TO All Plan Holders

ISSUE DATE 19 march 2021
PROJECT # 17-008.16

REGARDING Santa Cruz High School- Utility Replacement

DISTRICT Santa Cruz City Schools

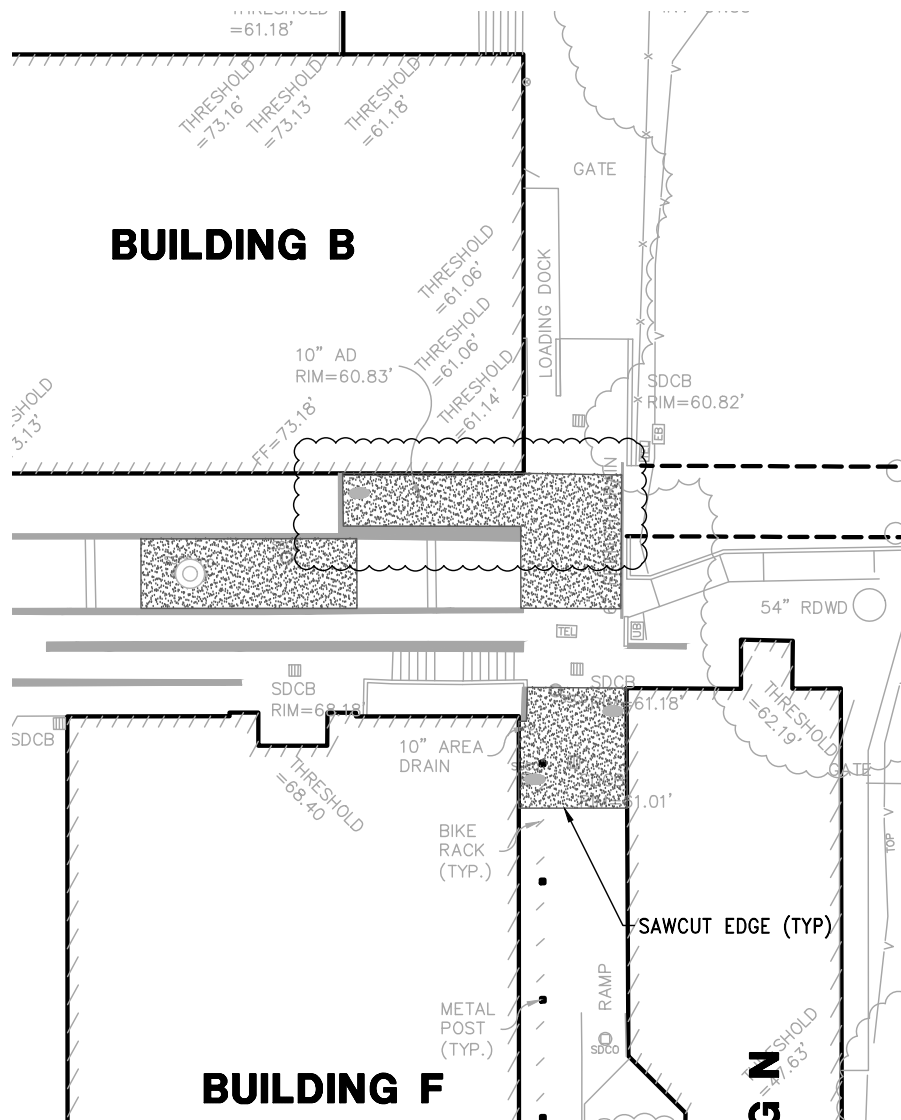
Sheet A1.0	Revise: Curb detail 2/ A1.1 to 2/A1.0. Curb detail is on Sheet A1.0.
	Sheet C3.0	Revise: Location of Building B SS POC per attached drawing.

Sheet C4.0	Revise: Area of concrete to remove and replace per attached drawing.
ATTENTION	PLEASE ENSURE THAT THIS ADDENDUM IS ACKNOWLEDGED ON YOUR BID
